Informal Review

Master Sign Plan

15-090MSP – BSD Scioto River Neighborhood District

Big Sandy Superstore – Dublin Village Center 6825 Dublin Center Drive

Main Entrance Detail

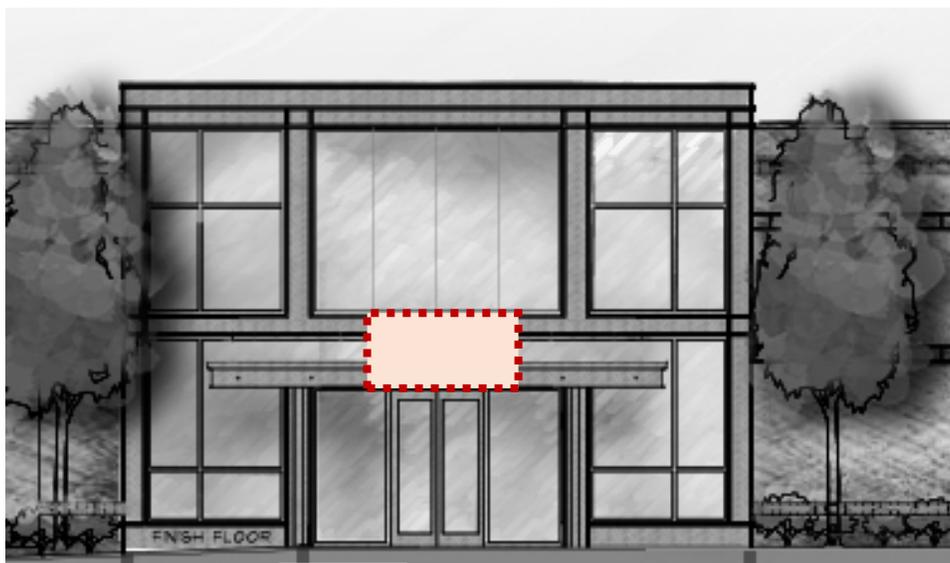
The proposed primary entry sign is 471.75 sq. ft. in size, based on a length of xx feet and a height of yy feet. The "Big Sandy" text is channel letters in the style of the Big Sandy trademark and is integrated into the main entry glass and steel curtain wall system. The "superstore" script sign, also part of the Big Sandy trademark, and is mounted to the entry canopy. Code allows 1/2 sq. ft. of sign for each lineal foot of building wall up to a maximum size of 50 sq. ft. The center section of the building façade could be calculated at 160 lineal feet, which results in an allowance for an 80 sq. ft. sign. The applicant stated that the sign was sized to be proportional to the scale of the entry. The entry atrium is 3,760 sq. ft. The sign area is 15% of the atrium entry area.

Left Side Entrance Detail

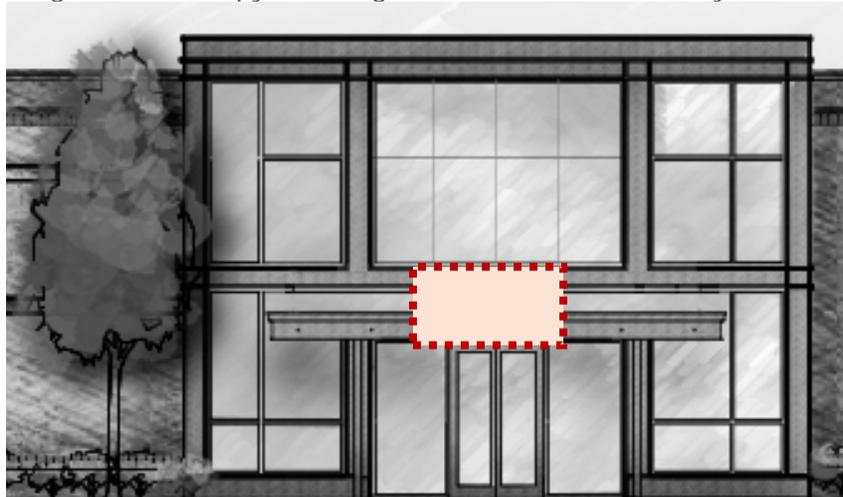
The 147.62 sq. ft. secondary entry sign (left of the primary entrance) is placed on the edge of the entry canopy, centered along the 140 lineal feet of front façade for this portion of the building. A moon, part of the Big Sandy trademark, is placed to the left of the text. The sign depth exceeds the code allowance of 12" due to placement along the edge of the canopy. The sign area is 10% of the entry atrium.

Right Side Entrance Detail

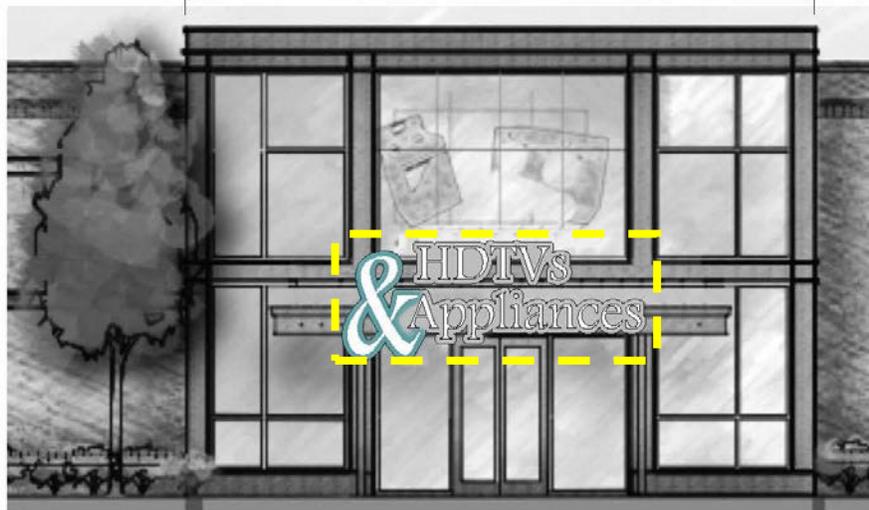
The 135.33 sq. ft. secondary entry sign (right of the primary entrance) is placed on the edge of the entry canopy, centered along 140 lineal feet of front façade for this portion of the building. The sign depth exceeds the code allowance of 12" due to its placement along the edge of the canopy. The sign area is 9% of the entry atrium.

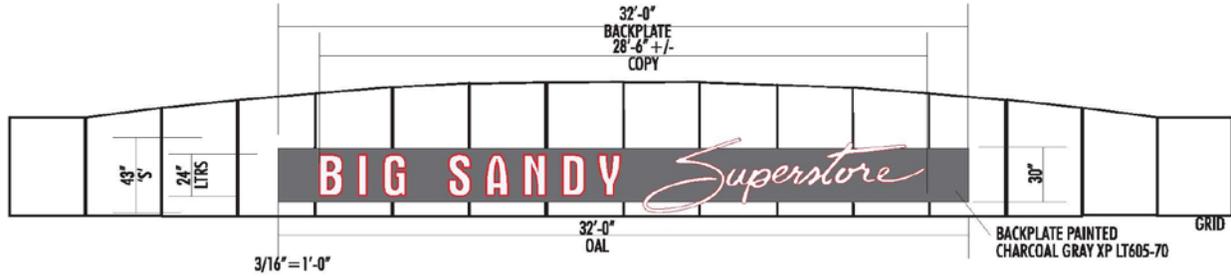
The previous submittals made use of fonts, which did not relate to the corporate image or trademark, the current application takes advantage of the corporate brand, as requested by the applicant. The first application was channel letters without a signature font, attached to a back plate.

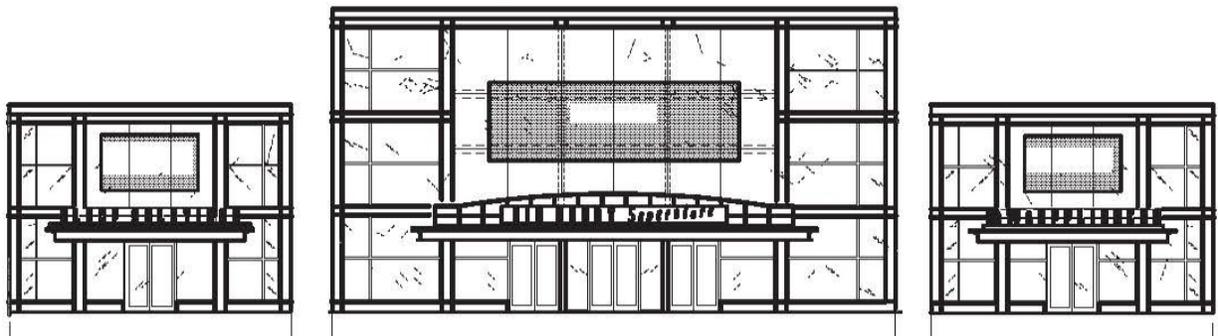
The revised application proposed the use of a single flat band of aluminum with routed letters placed on top of the entry canopies. Visually it was out of scale with the atrium.

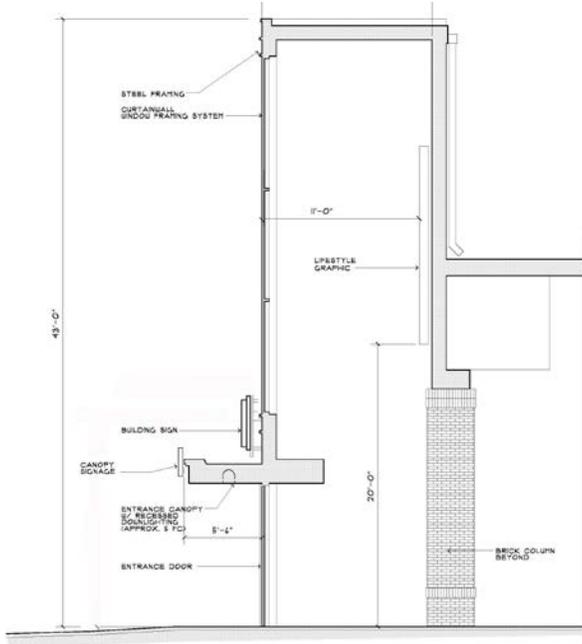
As noted in the sign description proposed signs are unbacked channel letters, which provide dimensionality, additionally, the script "Superstore" will be open face, lined with LED rope giving a look reminiscent of neon tube. This image illustrates this design approach.
